ECE/TRANS/WP.29/2009/64
9 April 2009

Proposal for Supplement 9 to Regulation No. 13-H
(Brakes of M₁ and N₁ vehicles)

Submitted by the Working Party on Brakes and Running Gear */

After Paragraph 5.11.9, insert a new section B, to read:

Figure 1a: Pedal force characteristic needed in order to achieve maximum deceleration with category "A" BAS

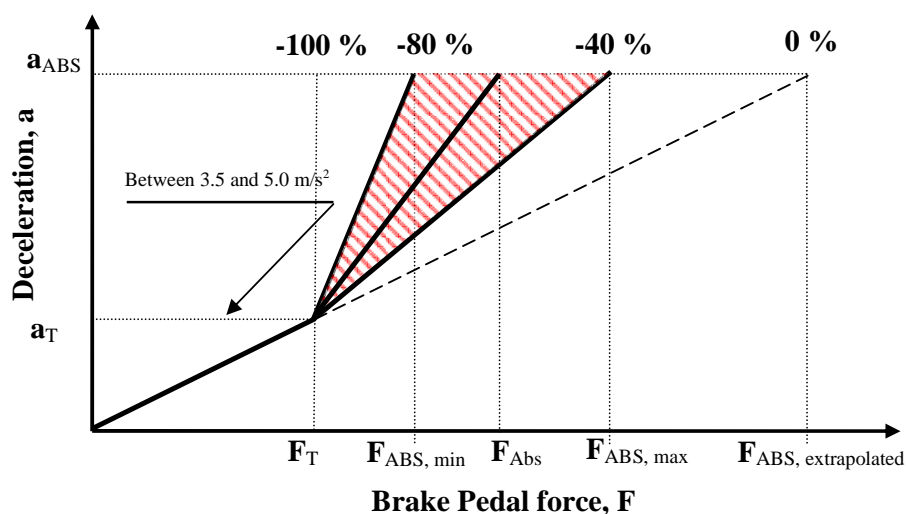
3.2.4. A straight line is drawn from the origin through the point F_T, a_T (as shown in Figure 1a). The value of brake pedal force "F", at the point of intersection between this line and a horizontal line defined by $a=a_{ABS}$, is defined as $F_{ABS, extrapolated}$:

Figure 1b: Pedal force characteristic needed in order to achieve maximum deceleration with category "A" BAS

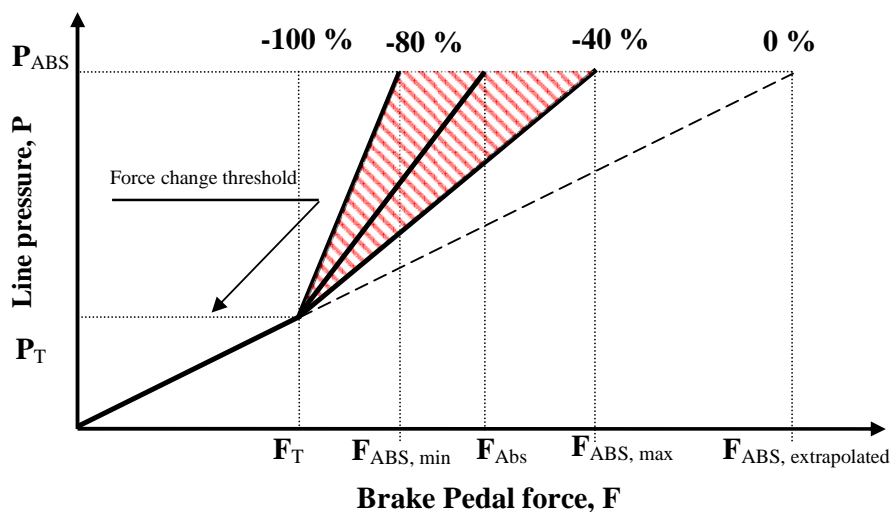
- 3.2.5.1. The pressure, at which ABS cycling commences, shall be determined by making five tests from 100 ± 2 km/h in which the brake pedal is applied up to the level which produces ABS operation and the five pressures at which this occurs as determined from front wheel pressure records, shall be recorded and the mean value obtained as P_{ABS} .
- 3.2.5.2. The threshold pressure P_T shall be stated by the manufacturer and correspond to a deceleration in the range of $2.5 - 4.5$ m/s².
- 3.2.5.3. Figure 1b shall be constructed in the manner set out in paragraph 3.2.4., but using line pressure measurements to define the parameters set out in paragraph 3.2.5. of this section where:

Figure 2: Example of test 2 of a category "B" BAS system

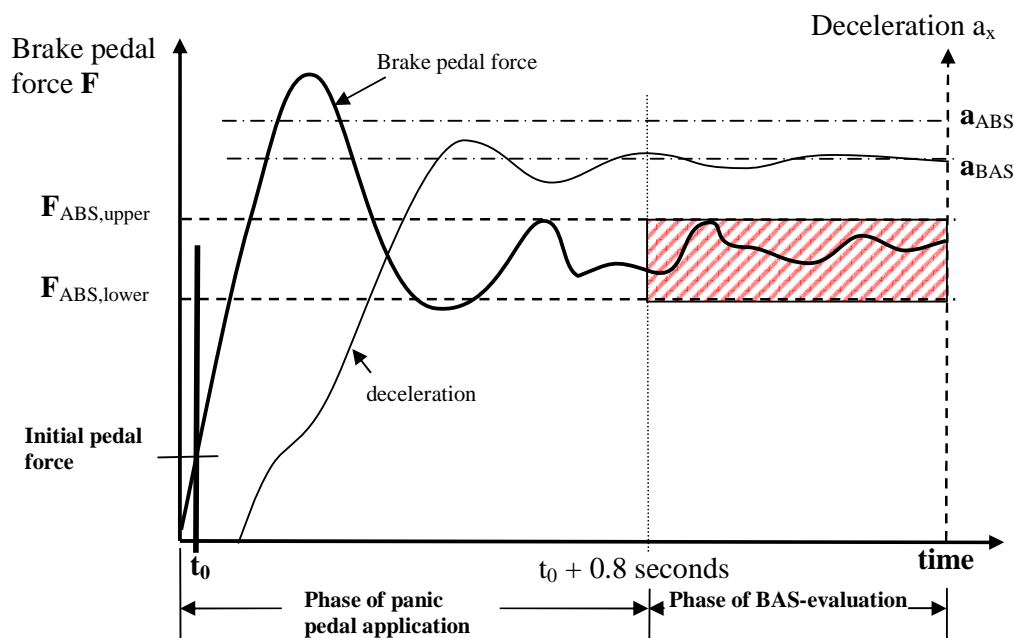
The vehicle shall be driven in a straight line at the test speed specified in paragraph 2.4. of this section. The driver shall apply the brake pedal quickly according to Figure 2, simulating emergency braking so that BAS is activated and ABS is fully cycling.

Figure 3: Deceleration corridor for determination of F_{ABS} and a_{ABS}

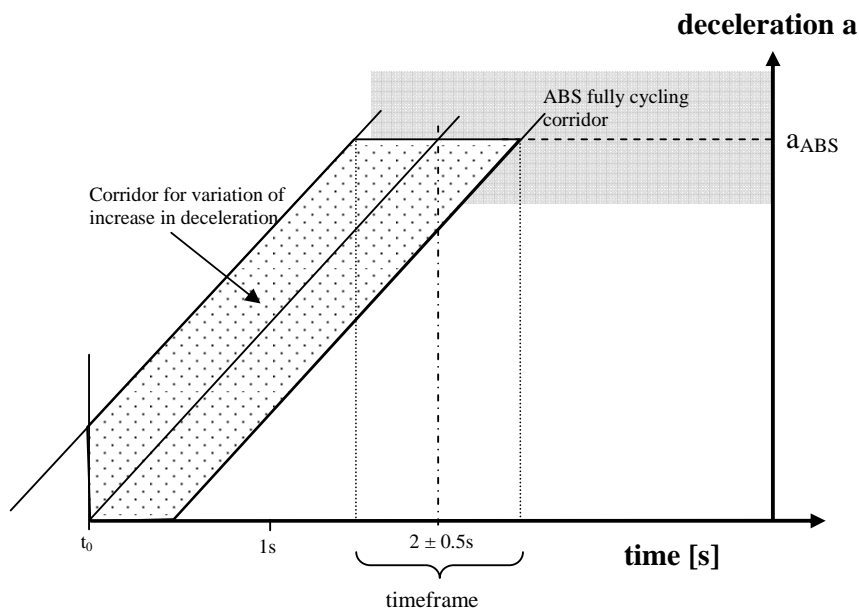
- 1.2. The brake pedal shall be applied slowly (without activating the BAS in the case of category B or category C systems) providing a constant increase of deceleration until ABS is fully cycling (Figure 3).

- 1.3. The full deceleration must be reached within the timeframe of 2.0 ± 0.5 s. The deceleration curve, recorded against time, must be within a corridor of ± 0.5 s around the centre line of the deceleration curve corridor. The example in Figure 3 has its origin at the time t_0 crossing the a_{ABS} line at 2 seconds. Once full deceleration has been achieved the pedal travel S_p shall not be decreased for at least 1 s. The time of full activation of the ABS system is defined as the time when pedal force F_{ABS} is achieved. The measurement shall be within the corridor for variation of increase in deceleration (see Figure 3).
